Block Island Wind Farm CVA

Status of Verification of Substructure
Installation (July 19 to November 24)

November 24, 2015

Location of Pile Weld Repair

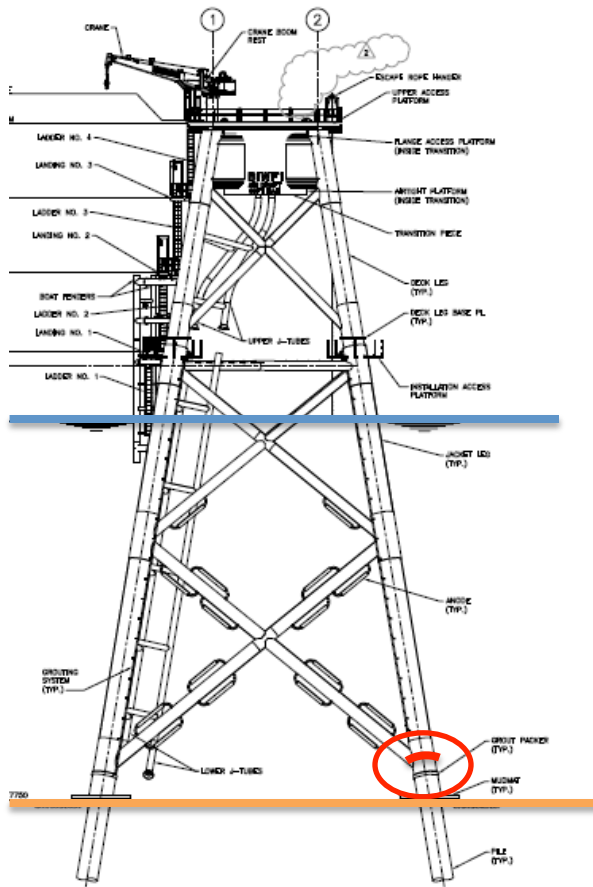
Repaired circumferential weld on four Jacket 1 piles at approx 2.5m above mudline

- Lifetime estimate based on scaling factors completed by designer
- DWBI agreed to perform an updated pile driving analysis during the last meeting (Oct 27), but now has requested ABS to reconsider where it is necessary based on the results of the estimate

Location of Pile Weld Repair

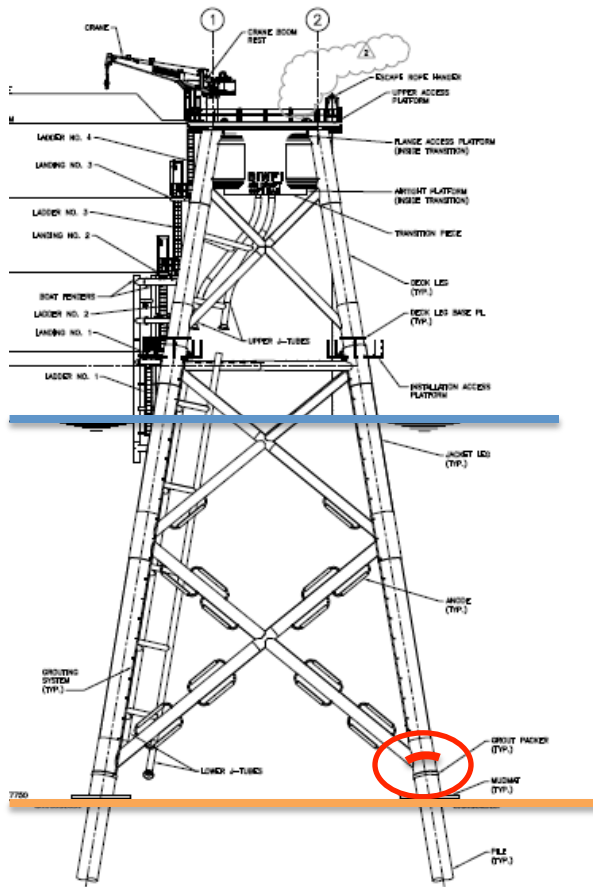
- ABS considers the full analysis important for increased confidence in lifetime of joint
- ABS does not consider estimate to be accurate enough to ensure life of joint; joint is not inspectable (above mudline, within grouted section of leg)
- Lifetime calculation is very sensitive to alignment of pile sections during the offshore repair – introduces uncertainty in the calculation
- If mitigation were found to be required, the only possibilities are during operation... Structural Monitoring, inspection or retrofit may or may not be feasible/ cost effective.

Status – ProvPort Tower Assembly

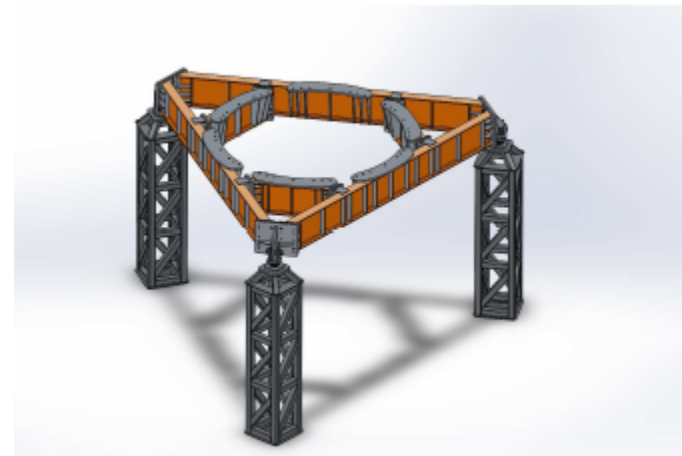
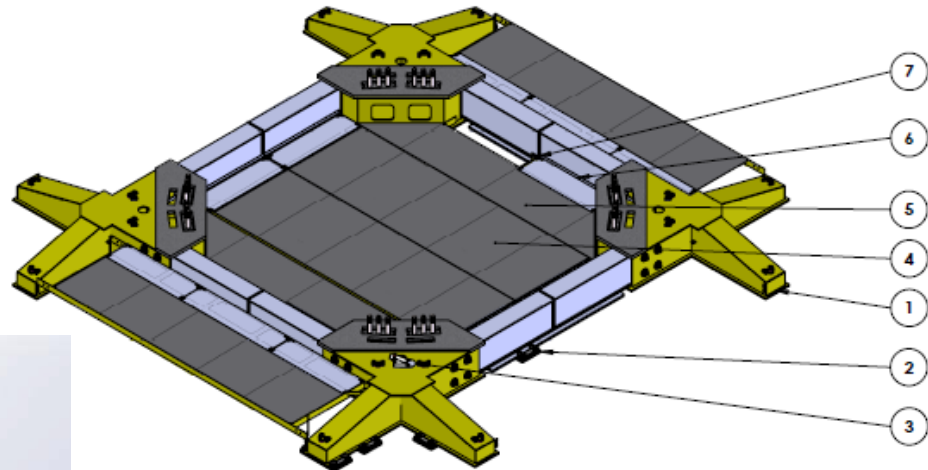
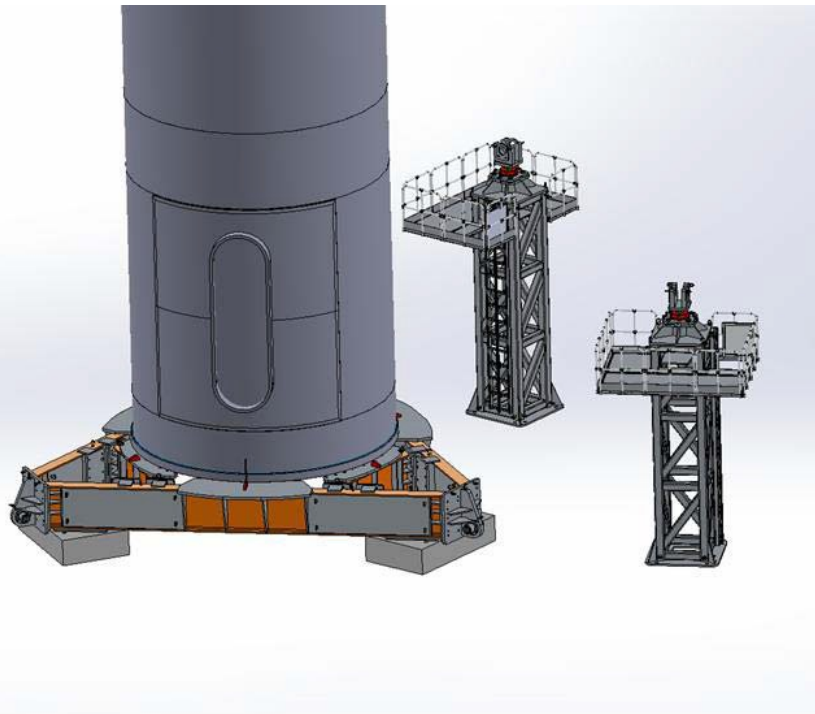
ABS is reviewing design calculations for concrete footings to hold tower storage frames and assembly frame.
